Product Updates in Cartridge Oil Filters

The following oil filter part numbers will be changing in appearance due to some product design updates:

1370, 7213, 7214, 7215, 7311,
7526, and 7674

Previous design sealing example

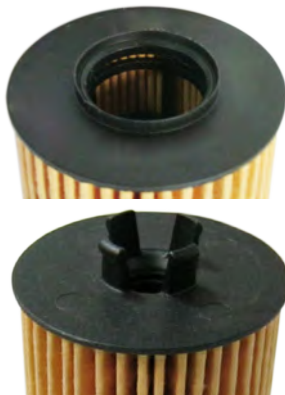
All filters are being updated with construction updates including higher strength end caps, center tubes; along with a switch to higher strength nitrile rubber seals.

The 1370, 7213, 7214, 7215, and 7311 use a design that incorporates skirted endcaps and a free floating bypass valve that uses the O.E. spring load in the housing standpipe.
